Access Compliance Report

Public Rights-of-Way

(Curb Ramps)

Intersection ID: 50589	Main Street: BENDING_BRANCH_RD	Cross Street: GREEN_GRASS_RD	Location: W
ADA ID: 01A024D9978E	Ramp Type: Perp	Initial Pass/Fail: Fail	Overall Compliance: No
Severity Score: 22.5			
Codes/Mitigation Info/Possible Solution		Field Measurements/Component Compliance

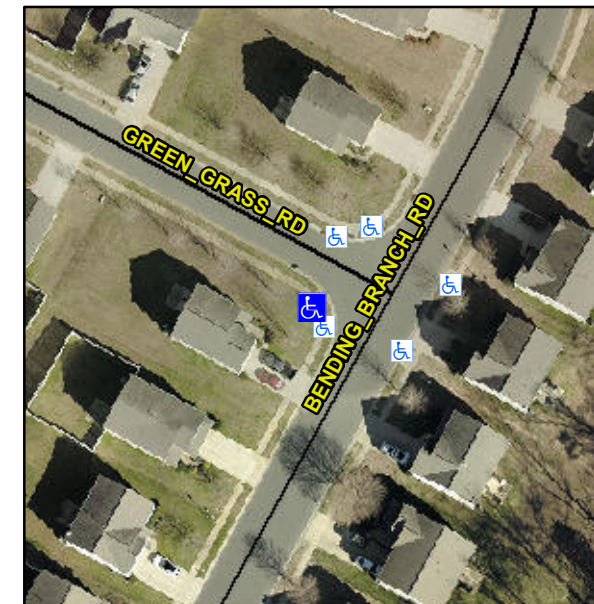
Not Found, R304.5.1, R304.2.2, R304.5.3

Compliance	Description	Data	Compliance	Description	Data
N/A	Ramp Length (in)	49.0	No	Ramp Slope (%)	9.0
No	Ramp Width (in)	47.5	No	Ramp XSlope (%)	3.9
N/A	Flare Type LT	N/A	N/A	Flare Type RT	N/A
N/A	Flare Slope LT (%)	N/A	N/A	Flare Slope RT (%)	N/A
N/A	Flare Traversable LT?	N/A	N/A	Flare Traversable RT?	N/A
N/A	Landing Length (in)	N/A	N/A	DWS Provided?	N/A
N/A	Landing Width (in)	N/A	N/A	DWS Contrast?	N/A
N/A	Landing Slope (%)	N/A	N/A	DWS Length (in)	N/A
N/A	Landing X Slope (%)	N/A	N/A	DWS Full Width?	N/A
N/A	Landing Curb? (Y/N)	N/A	N/A	DWS Offset (in)	N/A
N/A	Shared Landing?	N/A			
N/A	Gutter Ponding?	N/A	N/A	Gutter Slope (%)	N/A
N/A	Gutter Lip Ht (in)	N/A	N/A	Gutter X Slope (%)	N/A
N/A	Painted X Walk1?	No	N/A	Painted X Walk2?	N/A
	X Walk 1 Direction	To NE		X Walk 2 Direction	N/A
N/A	X Walk 1 Width (in)	N/A	N/A	X Walk 2 Width (in)	N/A
	X Walk 1 Slope (%)	1.3		X Walk 2 Slope (%)	N/A
	X Walk 1 X Slope (%)	3.5		X Walk 2 X Slope (%)	N/A

Remove & Replace Entire Ramp.
